CATAWBA NUCLEAR STATION, UNIT NOS. 1 AND 2
DOCKET NOS. 50-413 AND 50-414
RENEWED LICENSE NOS. NPF-35 AND NPF-52

**SUBJECT: RESPONSE TO NRC REQUEST FOR ADDITIONAL INFORMATION (RAI)
RELATED TO A LAR TO REVISE THE UPDATED FINAL SAFETY ANALYSIS
REPORT TO REFLECT ELECTRICAL POWER SYSTEM ALIGNMENTS FOR
SHARED SYSTEMS**

Response to NRC Request for Additional Information

Figure 1: Unit 1 "A" Train 4160VAC Electrical Power System

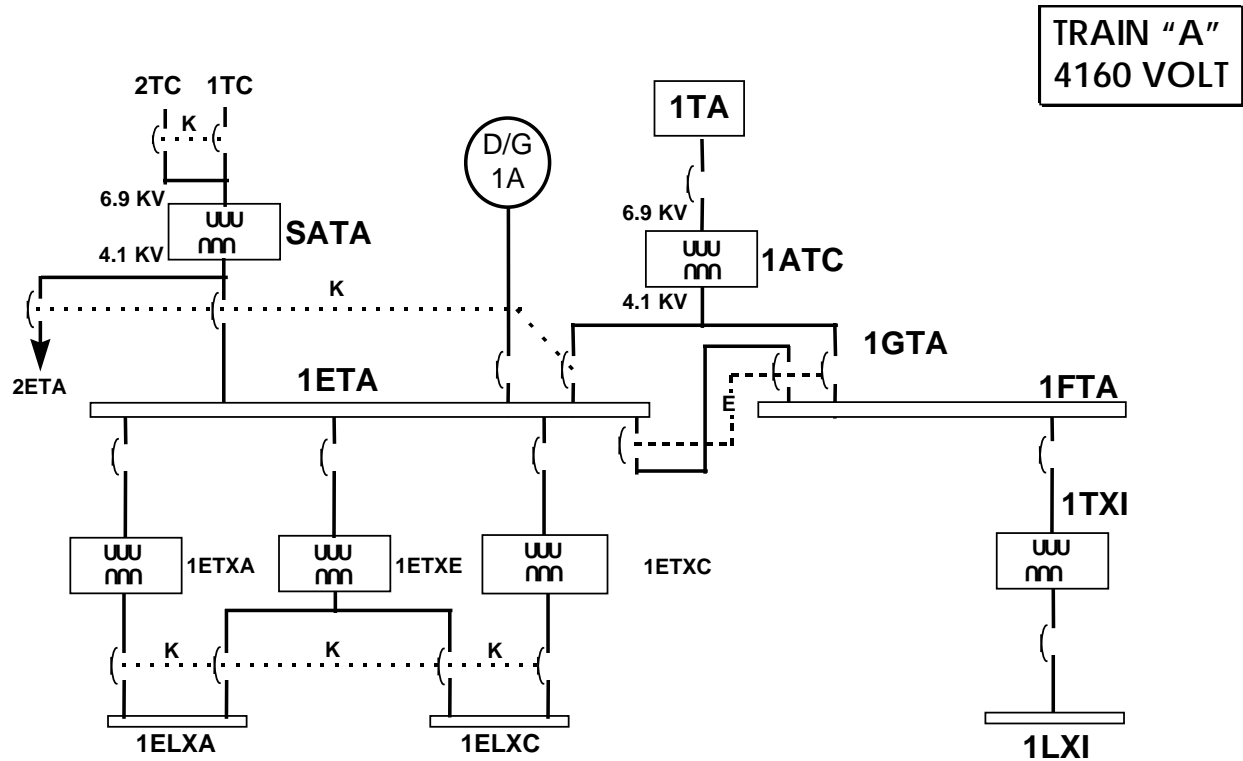
With a single line diagram, please explain how the electrical systems for each unit (power sources (both alternating current (ac) and direct current (dc), ac medium voltage buses and switchgears, distribution panels, load centers, motor control centers, and shared loads) are configured. For the following operating configurations, please identify (1) the applicable electrical-related technical specification (TS) requirements for each unit; (2) the operability of each shared structure, system, and component (SSC) (i.e., nuclear service water system (NSWS), control room area ventilation system (CRAVS), control room area chilled water system (CRACWS), and the auxiliary building filtered ventilation exhaust system (ABFVES)); and (3) the applicable TS required actions:

- a. When both units are in Modes 1-4;
- b. When both units are in Modes 1-4 and Train A of one unit is undergoing engineered safety feature (ESF) testing;
- c. When both units are in Modes 1-4 and Train A of both units is undergoing ESF testing, if performed;
- d. When one unit (Unit 1) is in Modes 1-4 and the other unit is in Modes 5-6; and
- e. When one unit (Unit 1) is in Modes 1-4 and the other unit is in Modes 5-6 and undergoing ESF testing.

Figures 1 and 2 below show the 4160v and 600v electrical power systems for CNS Unit 1 A train. Unit 2 A train and both Unit 1 and 2 B trains are similar, with the exception being the shared 600v motor control center 2EMXH. Motor control center 2EMXH would be in the same location as 1EMXG on the B train. Normally 1EMXG is powered from Unit 1 A train via load center 1ELXA and 2EMXH is powered from Unit 2 B Train via load center 2ELXB. 1EMXG can also be powered from Unit 2 A train via load center 2ELXA and 2EMXH can be powered from Unit 1 B train via load center 1ELXB.

- b. Referencing Figures 1 and 2 provided in the response to RAI 5, the units are electrically separated by use of interlocks to prevent the units from being electrically tied together. CNS employs several Kirk Key Interlock schemes that allow only one circuit breaker to be closed at a time using “break-before-make” procedural actions. The ESF testing alignment requires CNS to power the shared 600v MCCs 1EMXG and 2EMXH from the essential bus undergoing the ESF test. For example, Unit 2 essential bus 2ETA undergoing ESF testing would require 1EMXG (“A” train) to be aligned to 2ETA via load center 2ELXA. Shared MCC 1EMXG would be transferred to 2ELXA via a procedure that would de-energize 1EMXG by separating power from load center 1ELXA, and then re-energize 1EMXG from 2ELXA. Unit power separation is maintained at all times.

Figure 2: Unit 1 "A" Train 600VAC Electrical Power System

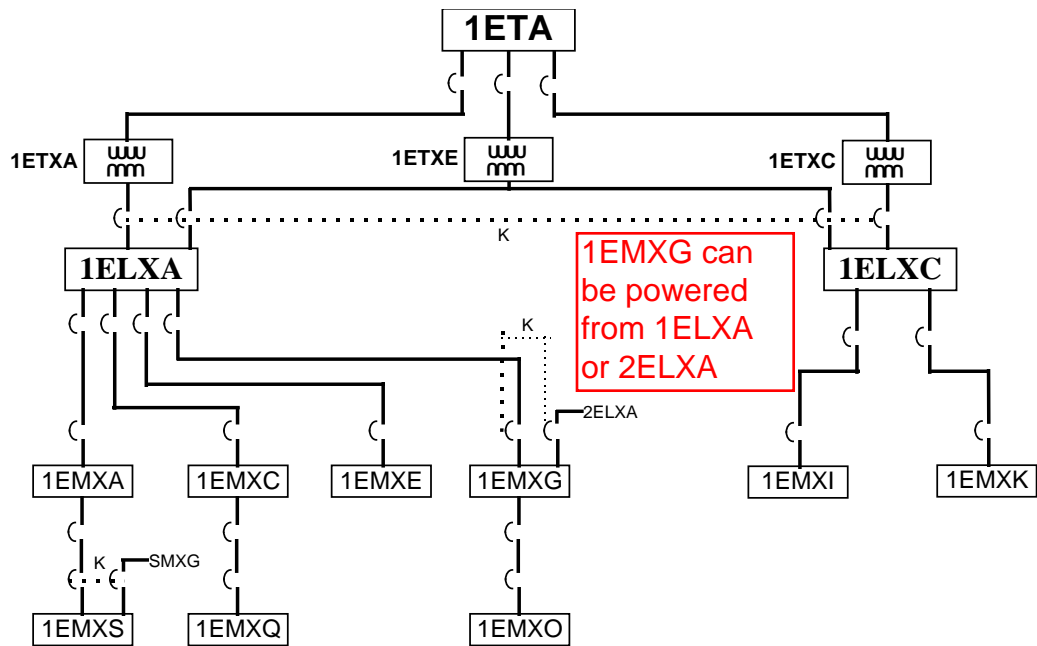
- a. Please clarify whether there are any cross-tie between CNS, Unit 1, and CNS, Unit 2, and between divisions within each unit. If cross-ties exist, explain how CNS meets 10 CFR Part 50 Appendix A, General Design Criterion 5, "Sharing of structures, systems, and components."
- b. Please explain, with a diagram, how the above UFSAR statement is met during normal operation with ESF testing and also when one unit's EDG is inoperable.
